STORM SEWER PLAN
VILLAGE ON THE PARWAY
VILLAGE PARKWAY VENTURE
 ALBERT H. H. ZEE ASSOCIATES, INC., ENGINEERS
 CITY OF ADDISON, TEXAS

STORM SEWER PLAN
VILLAGE ON THE PARKWAY
VILLAGE PARKWAY VENTURE
 ALBERT H. HALFF ASSOCIATES, INC., ENGINEERS
CITY OF ADDISON, TEXAS

IRRIGATION, TELEPHONE & ELECTRICAL CONDUIT SLEEVE PLAN

WATER & SANITARY SEWER PLANS						
VILLAGE ON THE PARKWAY						
VILLAGE PARKWAY VENTURE						
ALBERT H. HALFF ASSOCIATES, INC. - ENGINEERS						
CITY OF ADDISON, TEXAS						
DESIGN	DRAWN	DATE	SCALE	NOTES	FILE	NO.
AHH	T.P.	MAY 1978	1"=50'	6143	4110	1960

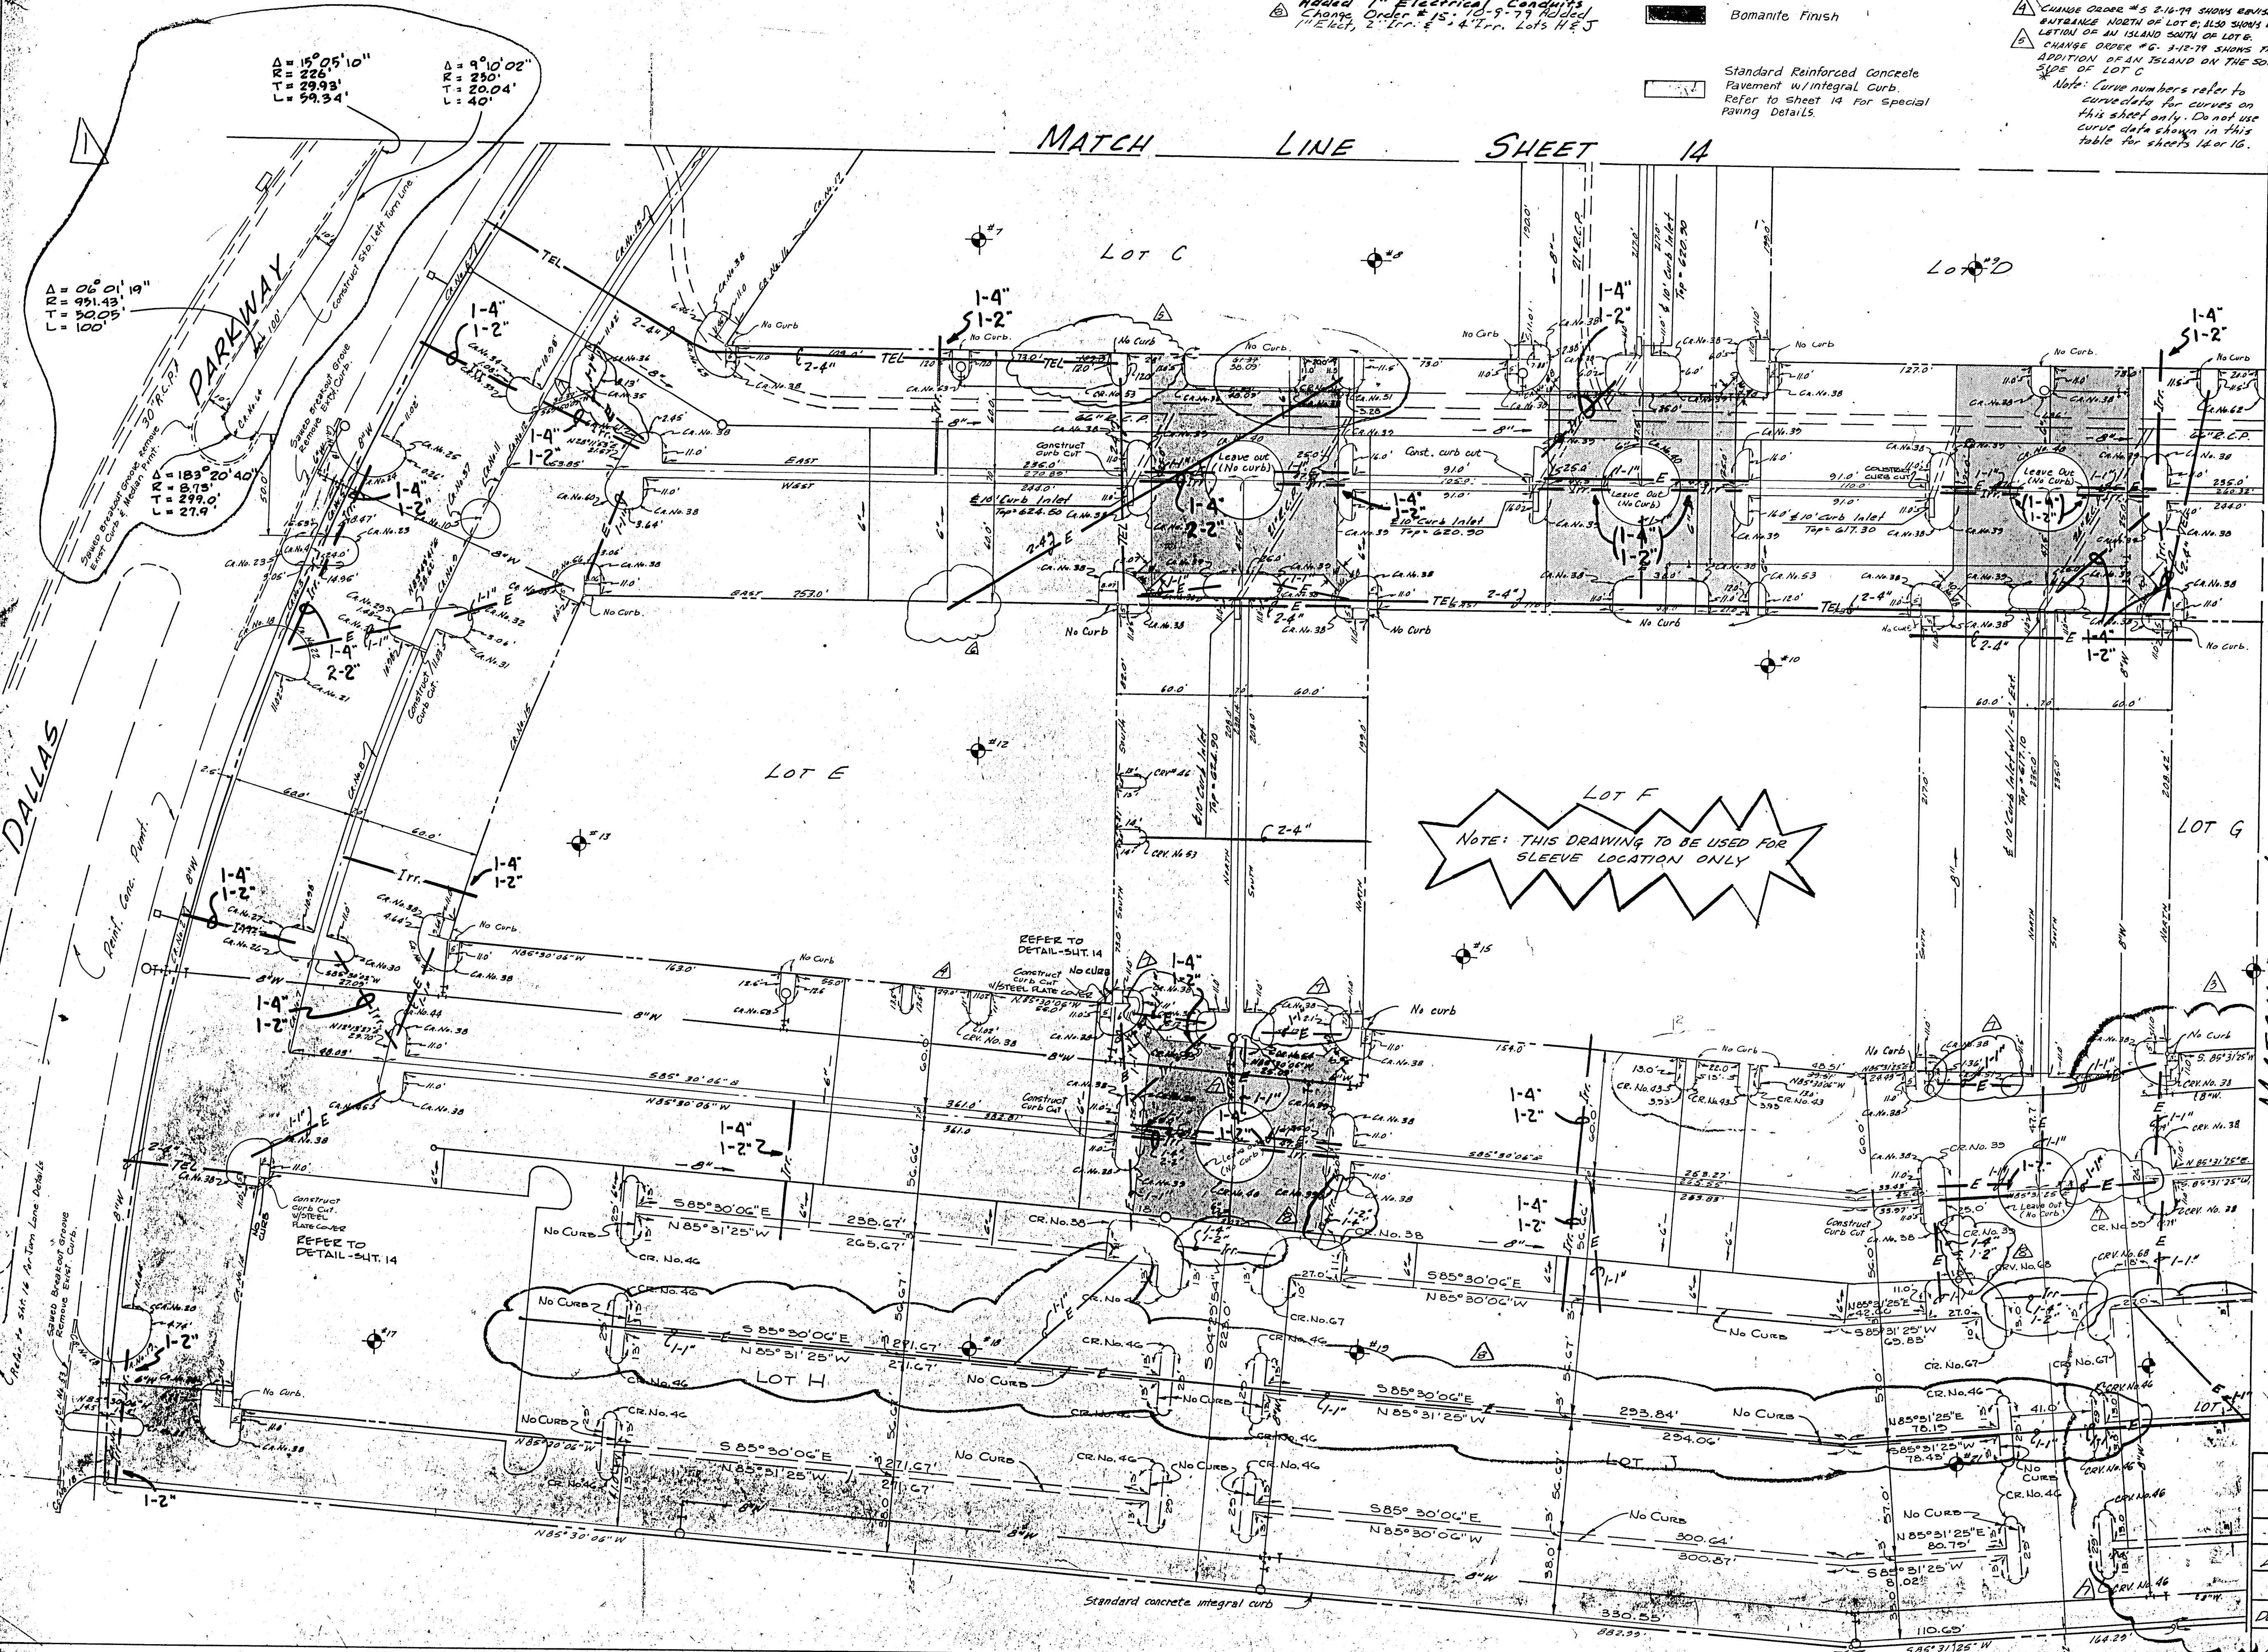
- NOTE: ALL DIMENSIONS ARE TO BACK OF CURB.
- ALL CURBS SHALL BE STANDARD OR CONCRETE INTEGRAL CURBS UNLESS OTHERWISE NOTED.
 - BOUNDMATE FINISH
 - HOT MIX ASPHALTIC CONCRETE 1.5" THICK
 - STANDARD REINFORCED CONCRETE PAVEMENT w/ INTEGRAL CURBS
- Change Order #4 1-2-79 Shows relocation of entrance @ south side lot B; Addition of island @ N.E. side lot B.
- Change Order #5 2-16-79 Shows revised elevation for top of inlet on median south of lot B.

Change Order #13 6-7-79
 Lengthened 2" Electrical Conduit sleeves
 to extend 6' past N. R. Lot E.

Change Order #14 8-2-79
 Added 1" Electrical Conduits
 Change Order #15 10-9-79 Added
 1" ELEC, 2" Tr. & 4" Tr. Lots H & J

2-28-79 Added Horizontal Layout
 and paving plan for second installment

Change Order #5 2-16-79 SHOWS REVISED
 ENTRANCE NORTH OF LOT E, ALSO SHOWS DE-
 LATION OF AN ISLAND SOUTH OF LOT E.

CHANGE ORDER #6 3-12-79 SHOWS THE
 ADDITION OF AN ISLAND ON THE SOUTH
 SIDE OF LOT C

IRRIGATION, TELEPHONE & ELECTRICAL CONDUIT SLEEVE PLAN						
VILLAGE ON THE PARKWAY						
VILLAGE PARKWAY VENTURE						
Albert H. Holt Associates, Inc. - Engineers						
CITY OF ADDISON, TEXAS						
DESIGN	DRAWN	DATE	SCALE	NOTES	FILE	No.
A.H.H.	A.H.H.	April 79	1"=20'	6183

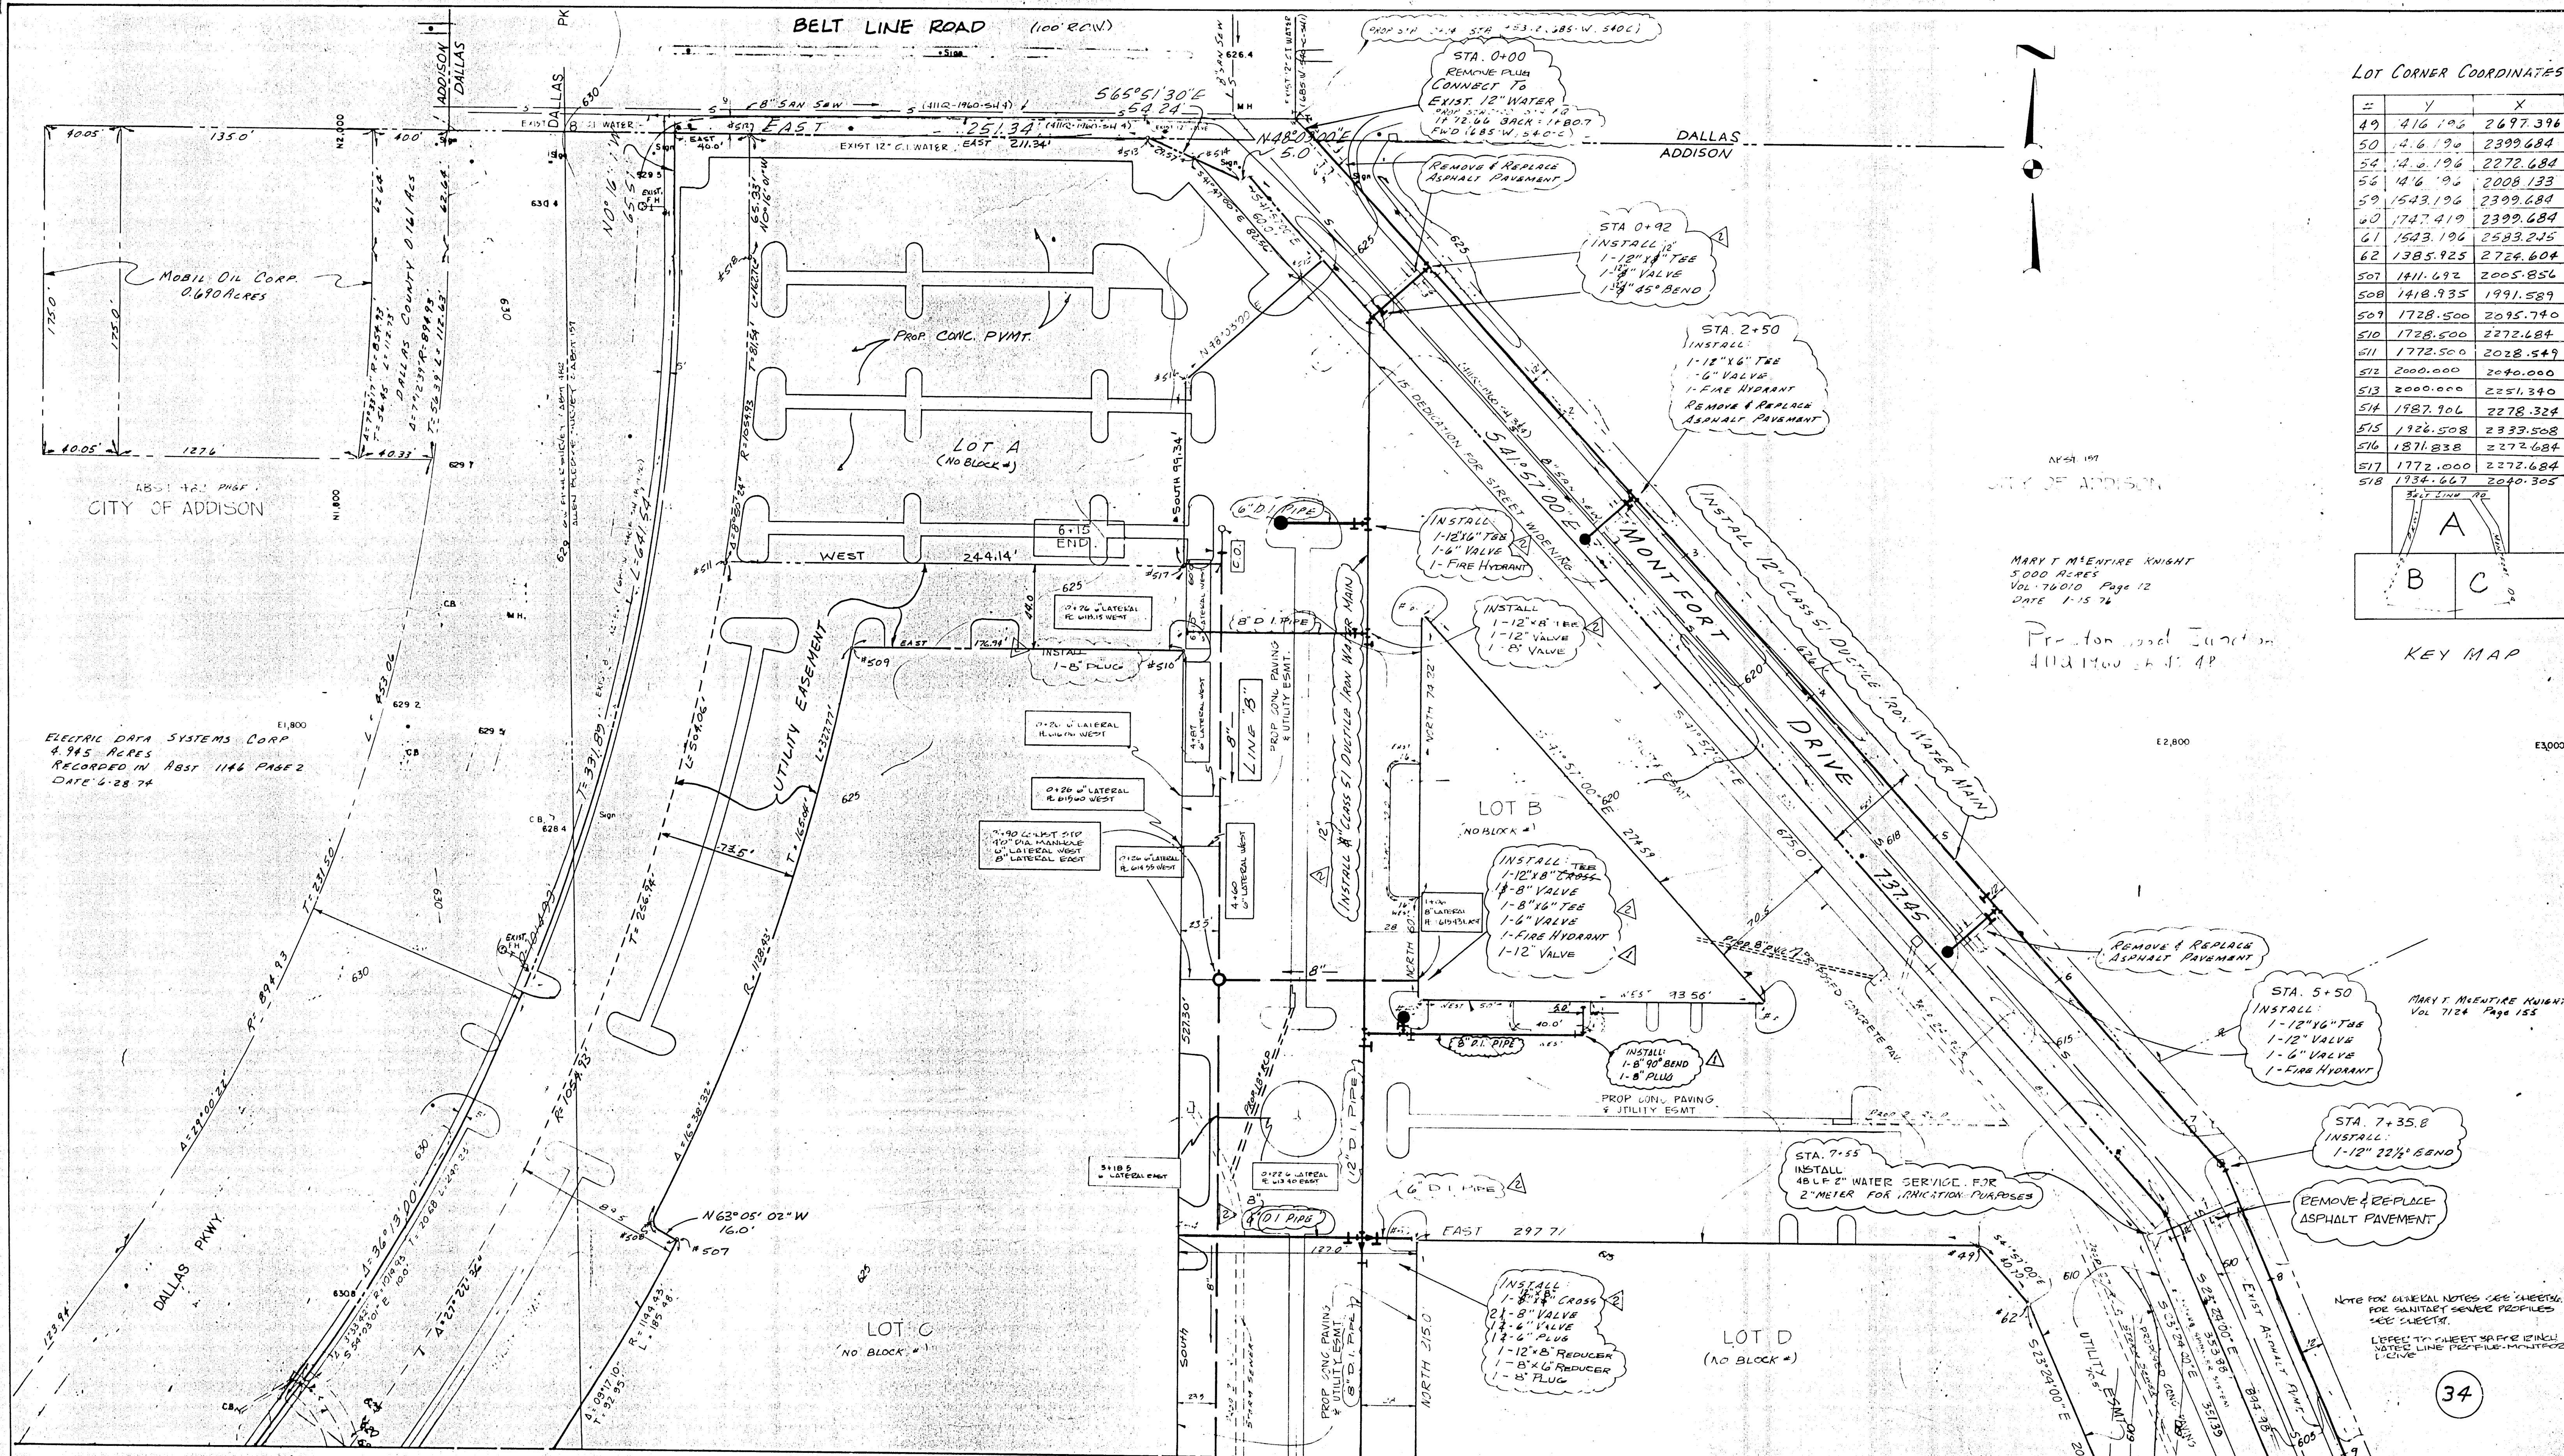
7/26/78 - Added TURN LANE CURVE DATA

10/30/78 REVISED SERVICE DRIVE DIMENSIONS SOUTH SIDE OF C&F

Change Order #14; 8-2-79 Added 1" Electrical Conduits
Change Order #15; Added 1" Elect Conduit North Entrance @ Montfort

2/28/79 Added Horizontal Layout & Paving plan for second installation.

7/26/78 Added TURN LANE CURVE DATA
